Date	Group	No.	Release	Page
6.2013	221	010	01	1(5)

Diagnostic Trouble Codes (DTC's), Low Oil Pressure (SPN 100 FMI 1)
CXU, GU, LEU, MRU
MP7 EPA2010

FSB 221-010, Diagnostic Trouble Codes (DTCs), Low Oil Pressure (SPN 100 FMI 1)

(June 2013)

W2078671

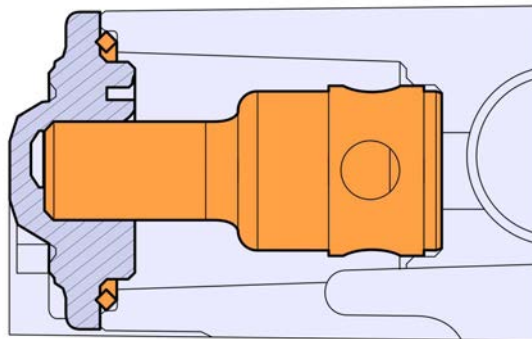
- 2 Disconnect all battery cables from the negative (ground) battery terminals to prevent personal injury from electrical shock and prevent damage to electrical components.
- 3 Remove and replace the oil pressure reduction valve with pressure reduction (regulating) valve part number 22192217, replace the internal o-ring with part number (469846), and replace cover o-ring with part number (949659) in the oil filter housing. Tighten cover fasteners to 10 ± 2 Nm (88 ± 17 in-lbs).

Note: During installation of the reduction valves, the cover must be flat against the oil filter housing before the bolts are installed to ensure the valve is seated flush against the sealing surface.

W2082022

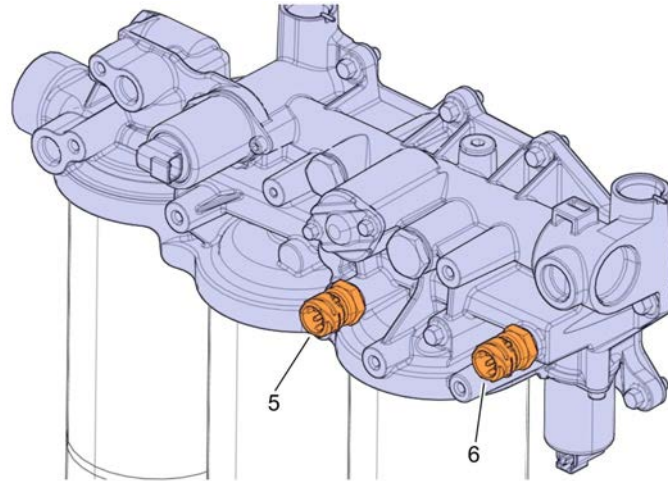
- 4 Remove and replace the EOP Sensor (6) and Engine Piston Cooling Oil pressure Sensor (5) with new sensor part number 21634021. Tighten sensors to 30 ± 5 Nm (22 ± 4 ft-lbs).

W2078872

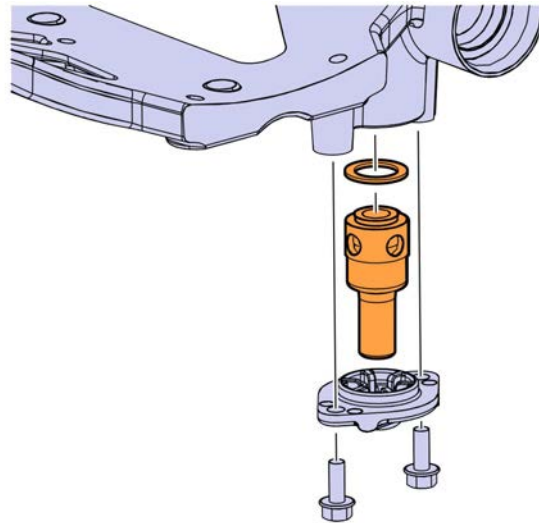
- 5 Remove the oil pan per instructions in Impact, Procedure 2171-03-02-01 Oil Pan, Replacement.
- 6 Remove and replace the pressure reduction (relief) valve in the oil valve body with part number (22188378), and replace the internal o-ring with part number (469846). Tighten cover fasteners to 10 ± 2 Nm (88 ± 17 in-lbs).
